**PLANNED UNIT DEVELOPMENT
& SUBDIVISION STAFF REPORT****Date: March 6, 2014****DEVELOPMENT NAME** Mock Subdivision**SUBDIVISION NAME** Mock Subdivision**LOCATION** 6377 Old Shell Road
(Southeast corner of Old Shell Road and Hillcrest Road)**CITY COUNCIL
DISTRICT** District 6**AREA OF PROPERTY** 2 Lots / 2.4± Acres**CONTEMPLATED USE** Planned Unit Development Approval to allow multiple buildings on a single building site and shared access between two building sites, and Subdivision approval to create two legal lots of record from two existing metes and bounds parcels.**TIME SCHEDULE
FOR DEVELOPMENT** Upon approval.**ENGINEERING**

SITE PLAN

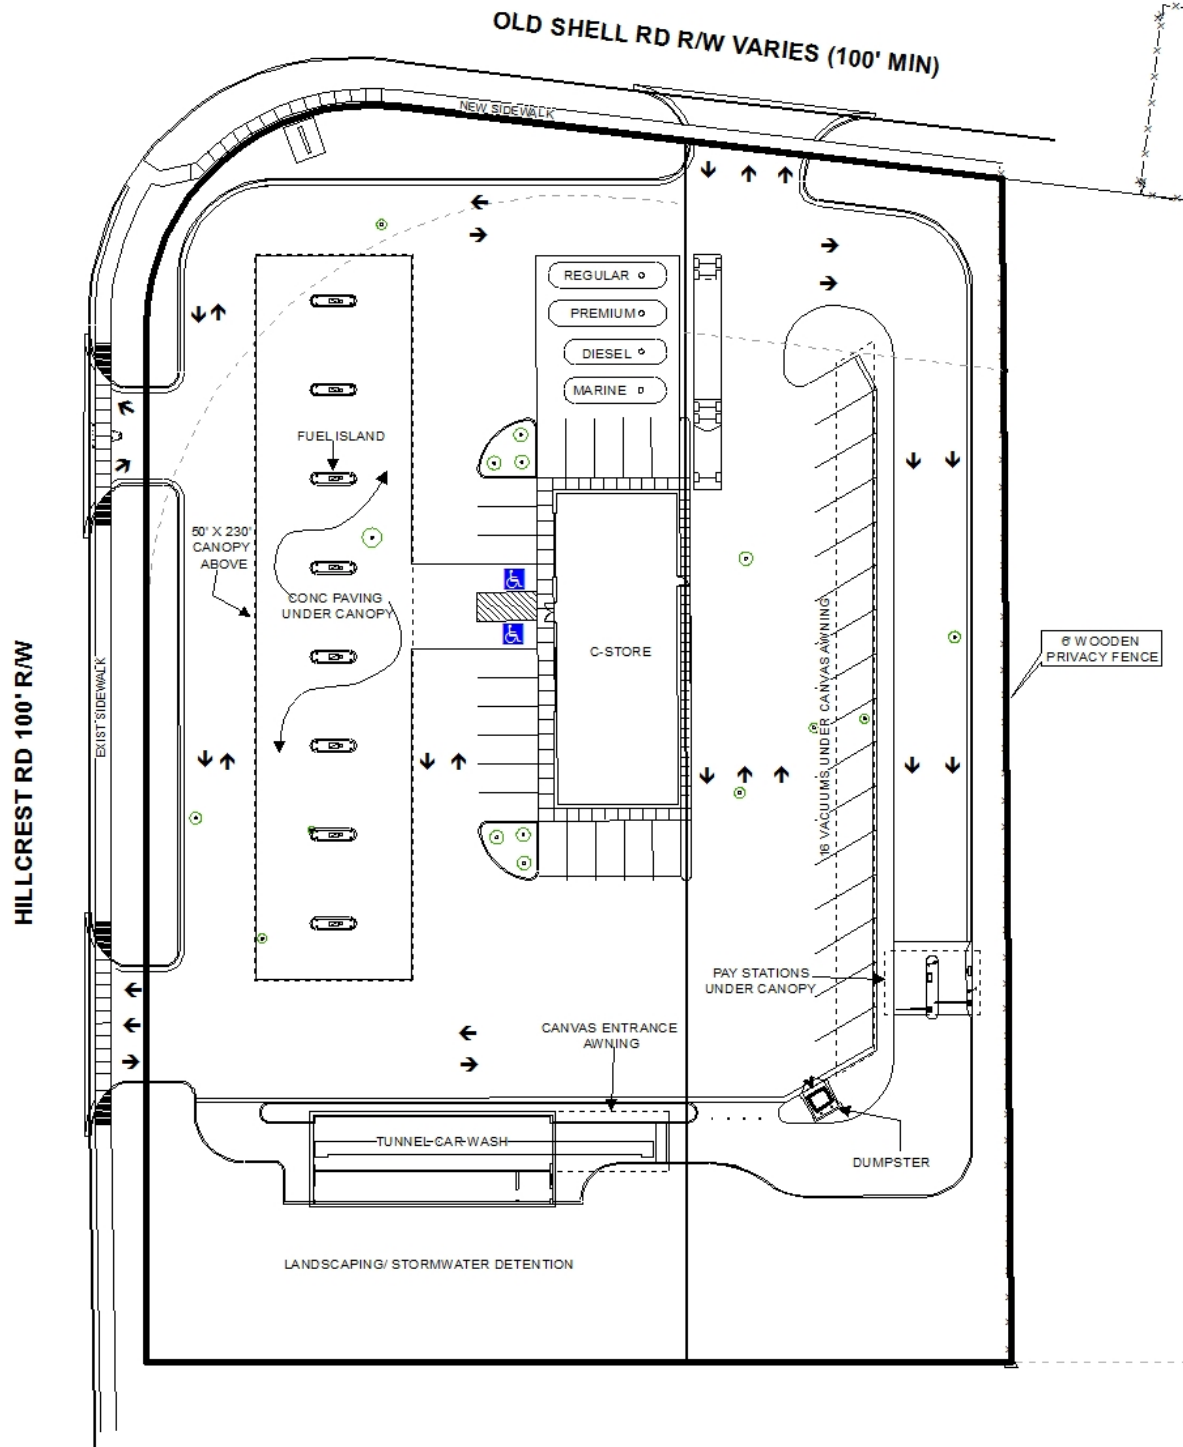
The site plan submitted indicates two proposed accesses from Hillcrest Road onto Lot A. As previously mentioned, the 1994 rezoning for that portion of the site restricted access along Hillcrest Road to the Southernmost boundary of the property, and Traffic Engineering has also limited the Hillcrest Road access to that one drive. The Old Shell Road drive is indicated to be one-lane ingress and two-lane egress indicating that exiting traffic could turn left or right onto Old Shell Road. However, Traffic Engineering has determined that traffic should be limited to right-turn-in and right-turn-exit only for this drive.

The site plan indicates several large trees on the site, but does not identify types and indicates that all trees on the site are to be removed. Urban Forestry has determined that Preservation status is to be given to the 72", 51" and 45" Live Oak Trees located on the center of the proposed development. Any work on or under these trees is to be permitted and coordinated with Urban Forestry; removal to be permitted only in the case of disease or impending danger. Two of the trees are within proposed paved access aisles, and one is within the area of the fuel island canopy. The site plan provides total landscaping calculations but no frontage landscaping calculations. Also, tree planting calculations do not provide for parking trees. The site coverage calculations are based on the store and car wash only and do not include the fuel island canopy, vacuuming facility awning or the car wash entrance awning. Parking calculations for the store/restaurant are one space short. A compliant dumpster is indicated as is a City-standard sidewalk within the right-of-way.

The site plan includes those areas proposed to be vacated along Old Shell Road and Hillcrest Road. As Traffic Engineering has expressed concerns relating to the scope of the proposed rights-of-way vacation, further coordination with Traffic Engineering should be made to revise the preliminary plat and site plan.

- 1) revision of the site plan to include modified right-of-way vacations which would be acceptable to Traffic Engineering to address the need for access to traffic signal equipment;

- 2) submission of a Traffic Impact Study based on the site's development intensity and location at a high volume intersection;
- 3) revision of the site plan to one curb-cut on Old Shell Road (right-in, right-out only), and one curb-cut to Hillcrest Road, with size, location and design to be approved by Traffic Engineering and conform to AASHTO standards;

- 4) revision of the site plan to specify handicap parking meeting ADA compliance;
- 5) revision of the site plan to allow Preservation status for the 72", 51" and 45" Live Oak Trees located on the center of the proposed development, as per the Urban Forestry comments;

- 6) revision of the site plan to identify the species of all existing trees on the site;
- 7) revision of the landscaping calculations to also include frontage landscaping required, and revision of the site plan to indicate such areas;

- 8) revision of the tree planting requirement calculations to provide required parking area trees;
- 9) revision of the site coverage calculations to include all proposed structures (store/restaurant, car wash, fuel island canopy, vacuum facility awning and car wash entrance awning); and

- 10) revision of the parking calculations for the store/restaurant to 20 spaces required.
